ADDENDUM #1

COMPETITIVE BID #WG20-39 – Purchase and Installation of One (1) New 300 kW Generator and One (1) New 400 AMP Automatic Transfer Switch for the Baldwin County Revenue Commission Building located in Bay Minette, Alabama

ADDENDUM # 1

ELECTRICAL FOR 300 K.W. GENERATOR
REVENUE Bldg. BAY MINETTE, AL.

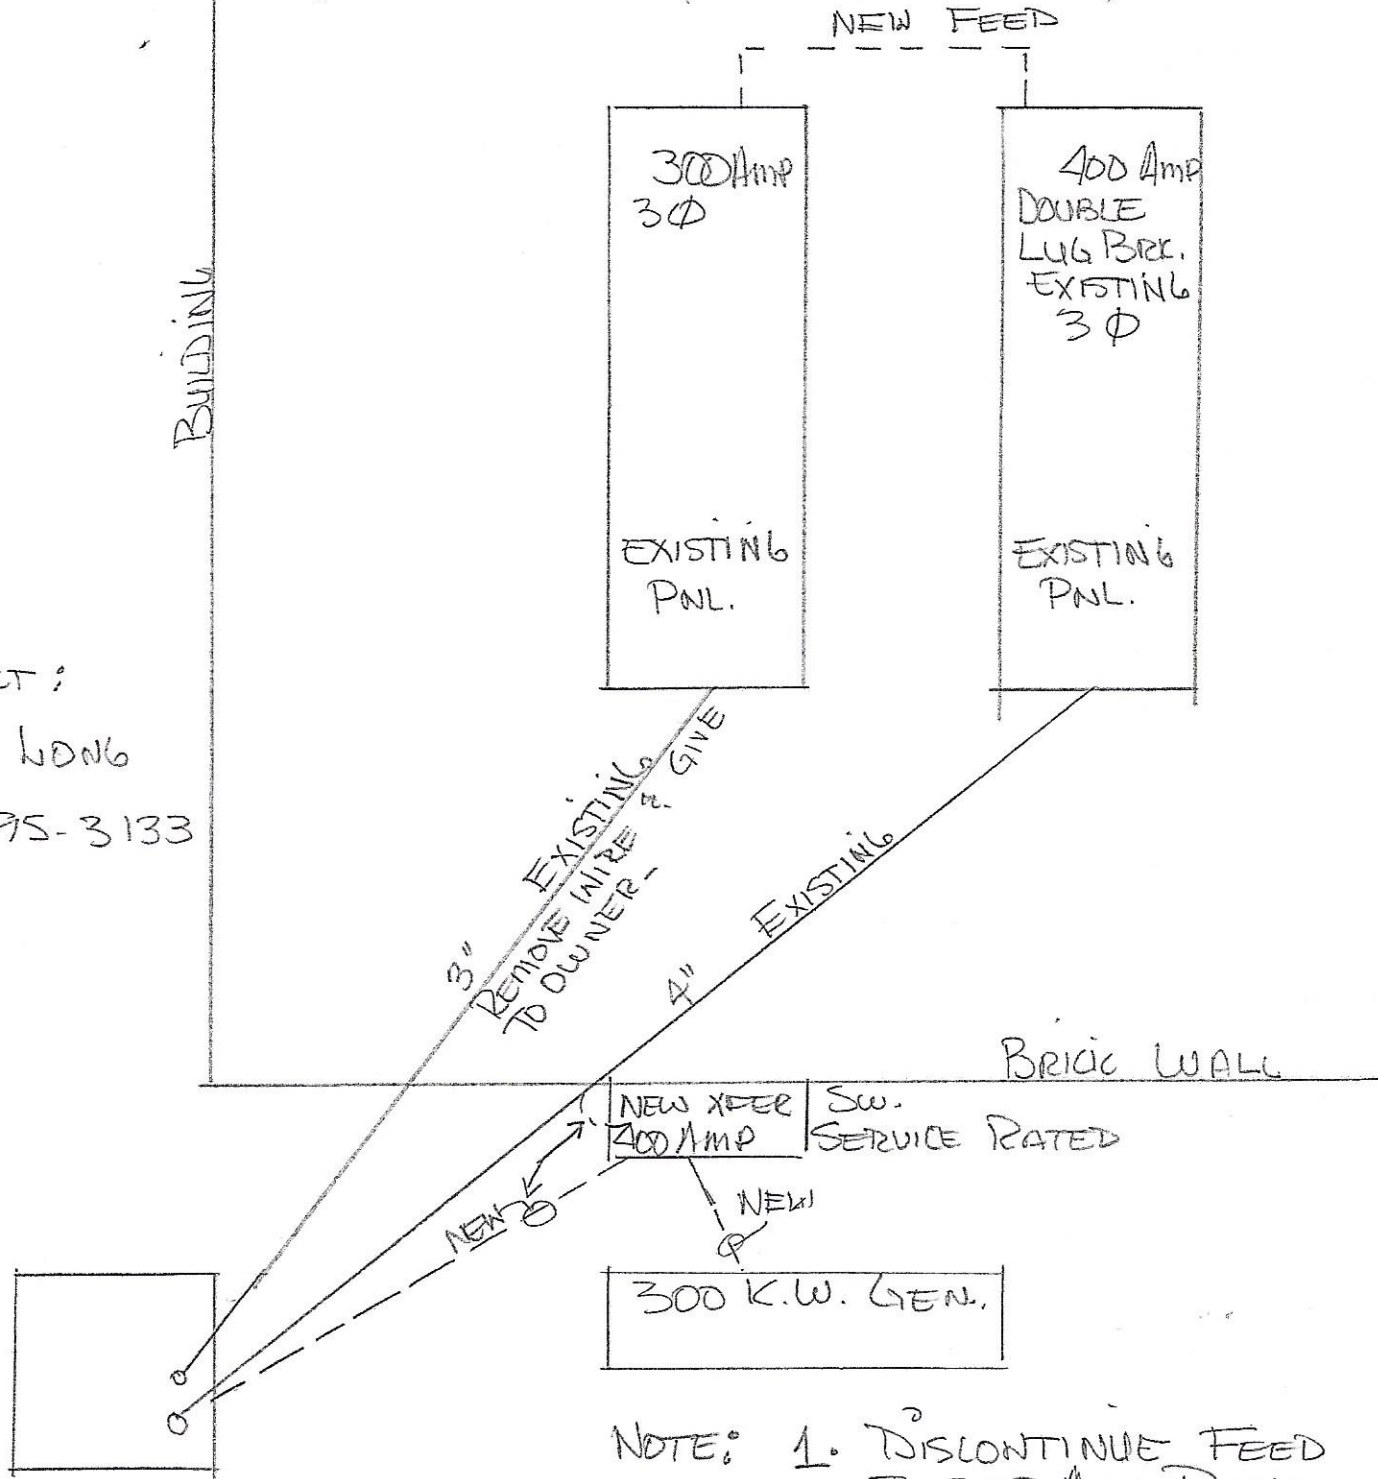
Remove feed from Alabama Power Company Transformer to 300 AMP main breaker located in electrical room, return all wire back to owner. Approximately 100 ft.

New feed to 300 AMP panel, will be from 400 AMP main breaker which has existing double lugs. This 400 AMP panel is in the electrical room next to 300 AMP panel.

NOTE: 1. DISCONTINUE FEED
TO 300 Amp PANEL.
2. FEED 300 Amp PANEL
FROM 400 Amp BREAKER
THAT IS EXISTING
